DS #: 4562

PROJECT: A-cab

SUBMITTAL: 1st

CITY OF LAS VEGAS		DATE:
INTER-OFFICE MEMORANDUM		August 2, 2012
TO: Land Development Services Department of Public Works		FROM: Albert Sung, P.E. Flood Control Project Engineer Department of Public Works
SUBJECT:	Drainage Study for:	COPIES TO:
	A-Cab	APTUS
Cross Streets:	SWQ of Bruce Street & Searles Avenue	Four Fours LLC
File Number:	F:\Depot\DSMemos\DS4562.doc	Bart Anderson, P.E., DevCo
Parcel Number:	139-26-201-004	
Zoning Action:	SDR-43399	
FEMA Flood Zone	YES NO X	
Proposed Storm Drain	YES NO X

Onsite Drainage Easement Worksheet for Irregular Channel

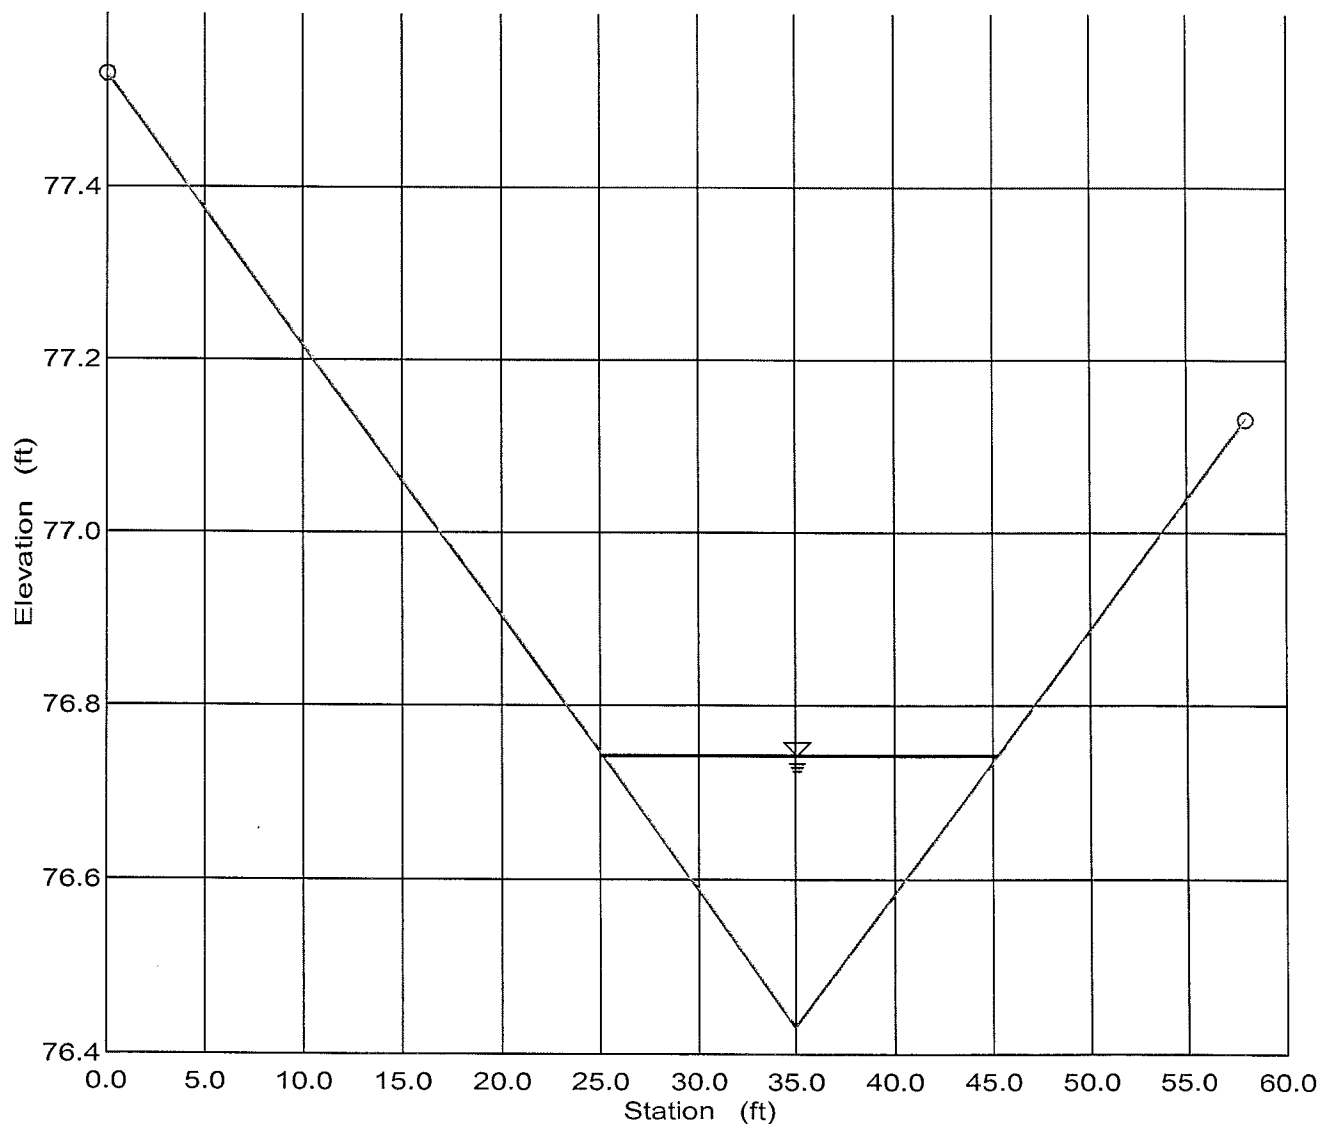
5. The FlowMaster calculation for the onsite drainage easement used a channel slope of 1% which as stated in Comment #4 is not correct. The actual slope in the drainage easement ranges from 0.25% to 0.8%. Review and re-calculate accordingly.
6. Revise the bar scale to show "1 inch = 30 ft." instead of "1" = 40 ft."

This grading plan is a part of drainage study #4562 which was received on 8/29/12 and Appl. on 9/13/12. Page 1 of 1
VICINITY MAP
NOT TO SCALE
CLV #

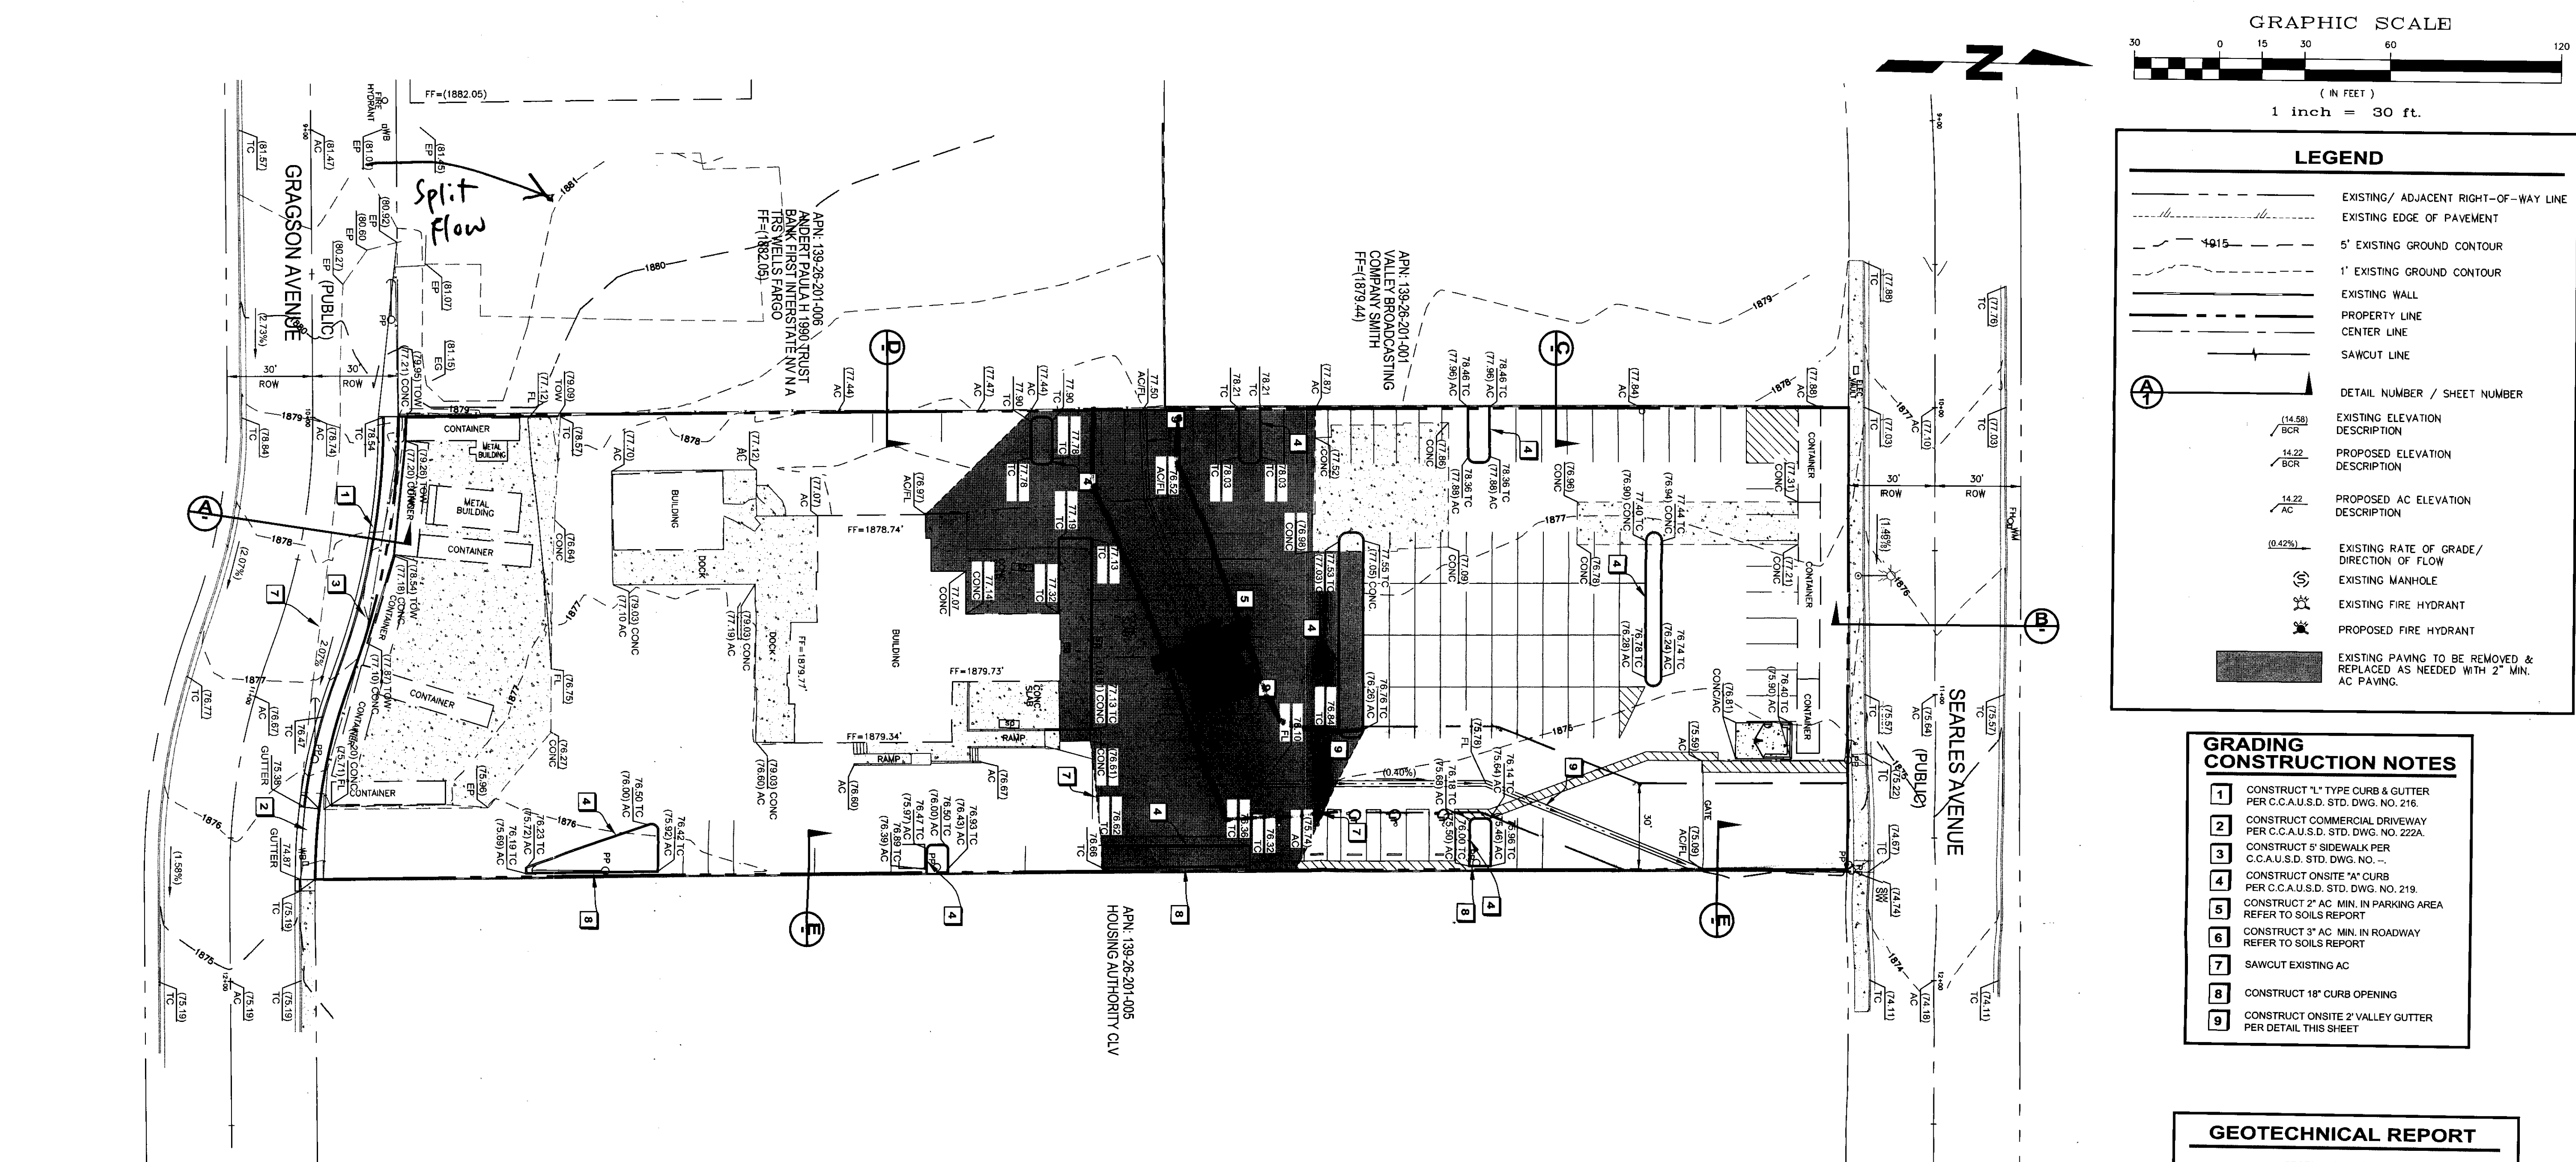
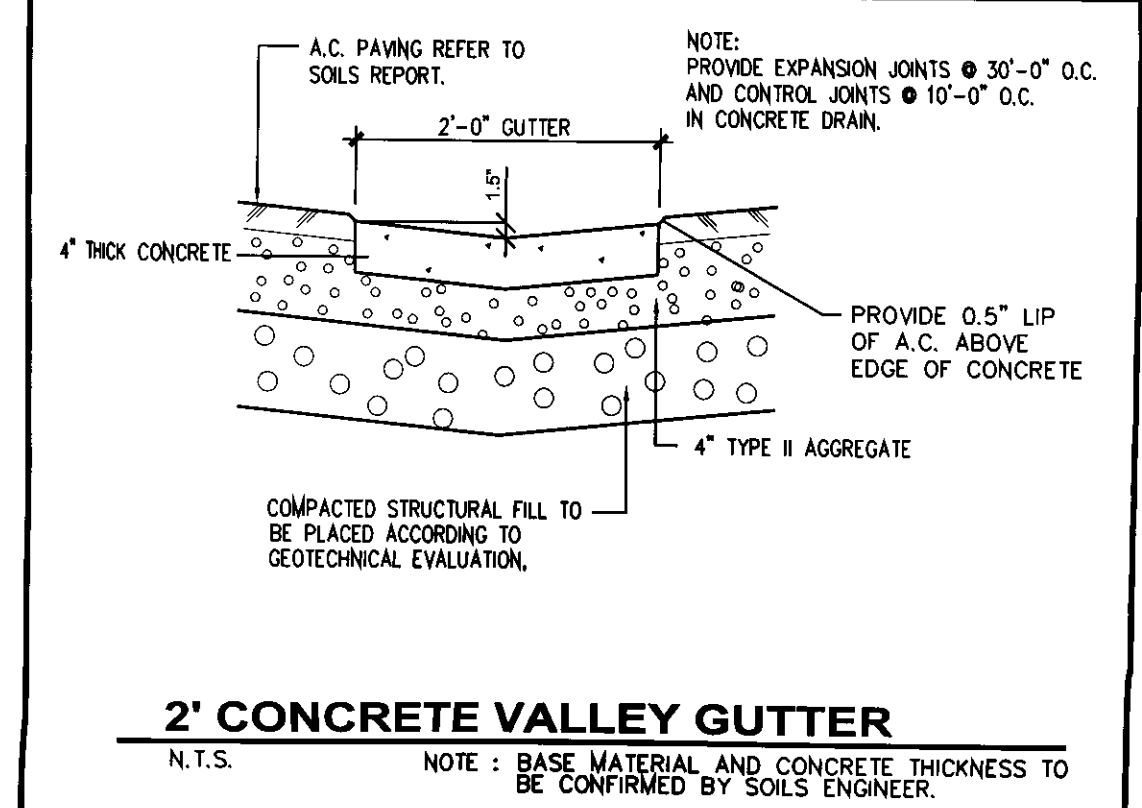
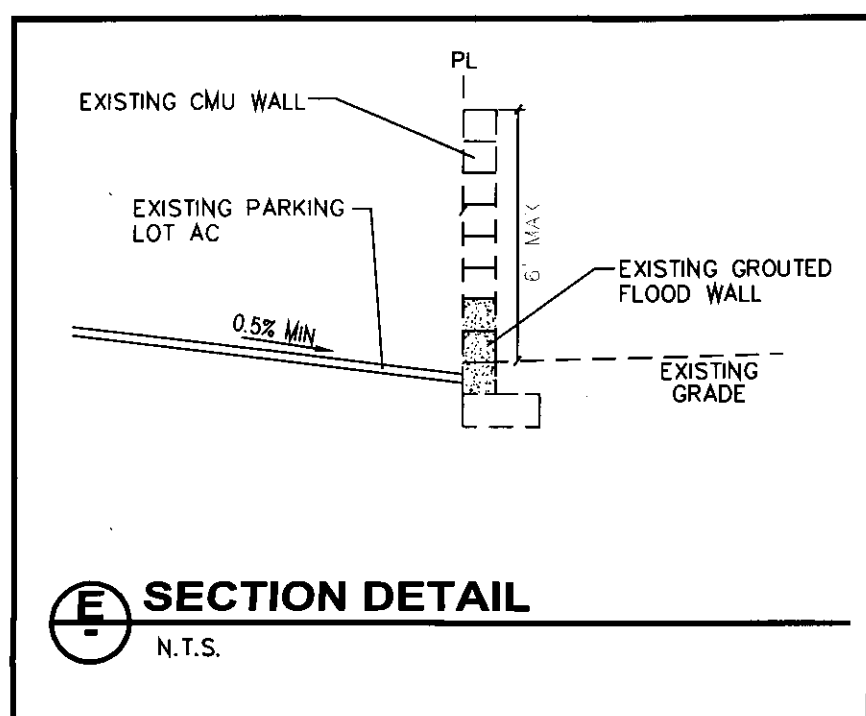
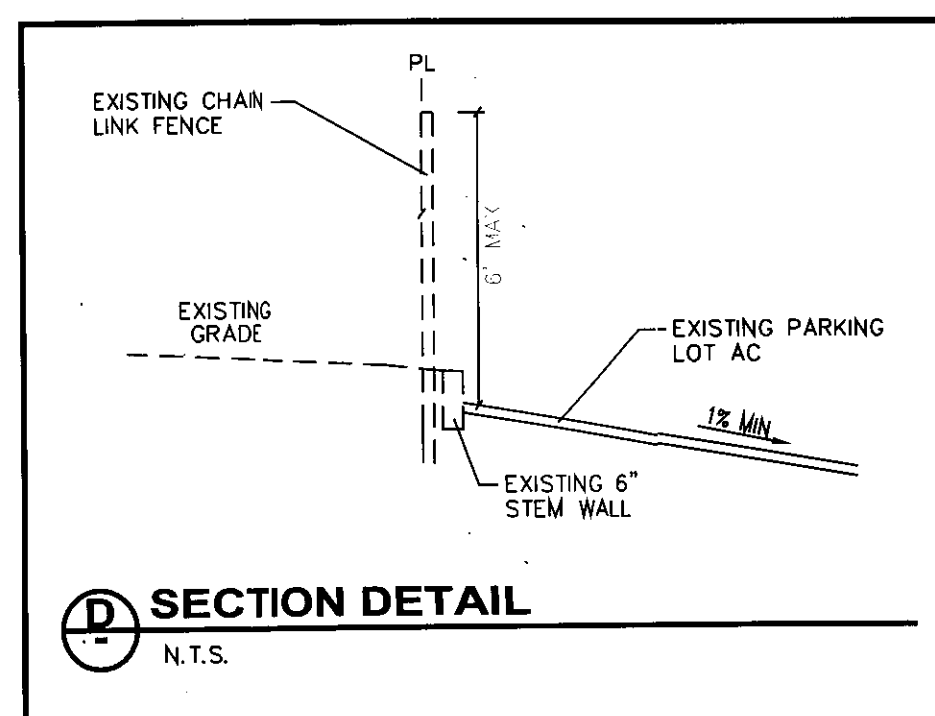
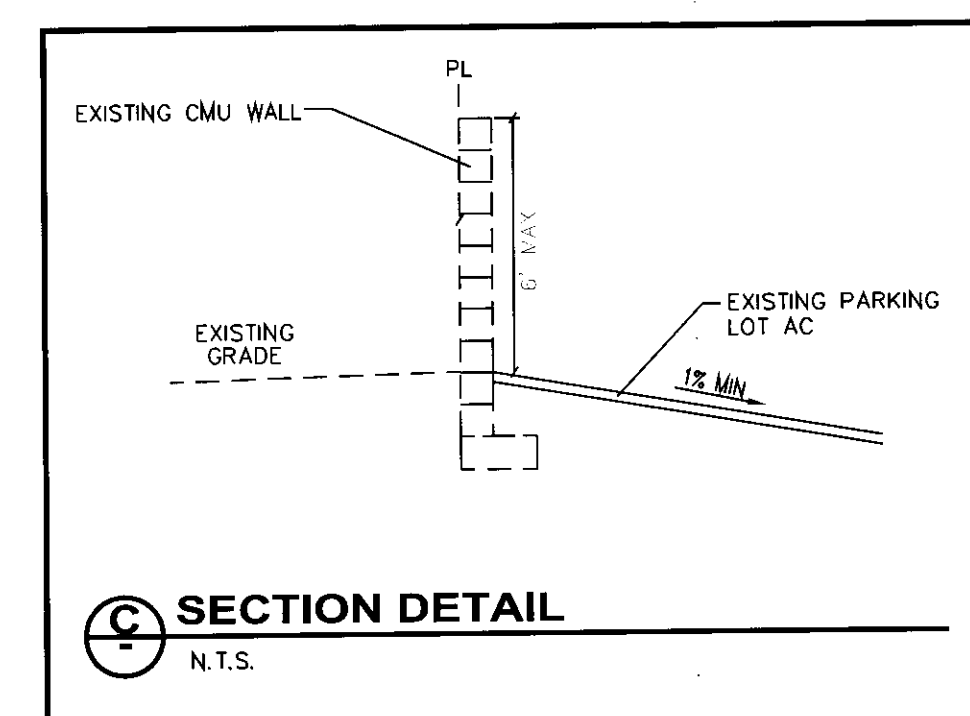
It appears that more survey shots / street grades are needed in Gragson Avenue upstream of the subject site to verify the location and width of the proposed weir for the split flow.
- The proposed 20'-drainage easement must be labeled as "Public Drainage Easement to be Privately Maintained" on the grading plan and to be granted as such by separate document prior to the final approval of the drainage study.
- The slope in the proposed drainage easement indicates very flat conveyance, ie, less than 1%. Provide a 2'-wide concrete valley gutter within the drainage easement. Provide hydraulic calculation to verify that the total width of the drainage easement contains the 100-year flow.
